Subject: **Palo Verde Nuclear Generating Station (PVNGS) Unit 2**
Docket No. STN 50-529
Exigent License Amendment Request to Amend Technical
Specification Surveillance Requirement 3.1.5.3 for Control
Element Assembly 88 for the Remainder of Unit 2, Cycle 19

Evaluation of the Proposed Change, Amendment to Technical Specification
Surveillance Requirement 3.1.5.3

Subject: **Request to Amend Technical Specification Surveillance Requirement 3.1.5.3 for Control Element Assembly 88 for the Remainder of Unit 2, Cycle 19**

Figure 1 –Before August 27, 2015

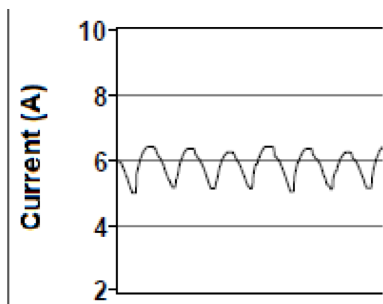
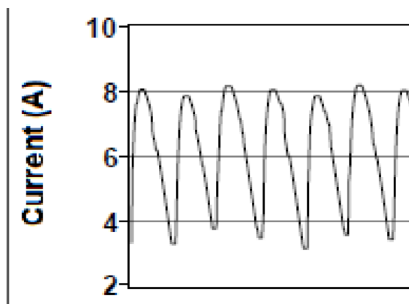
On August 27, 2015, during the monitoring program data collection, the UGC for CEA 88 was found to have exceeded the monitoring threshold value for current noise and the holding function was transferred to the lower gripper coil, de-energizing the UGC. The monitoring activity trends the UGC current noise, which is the range of oscillation above and below the set UGC current value.

The monitoring results prior to August 27, 2015, reflect a consistent peak-to-peak gripper coil current noise level of 1.4 amps. On August 27, the peak-to-peak current noise level increased to 4.83 amps. This exceeded the monitoring threshold value of 2.5 amps for transferring the holding function of the CEA to the lower gripper coil.

The two following figures show the step change in coil current noise:
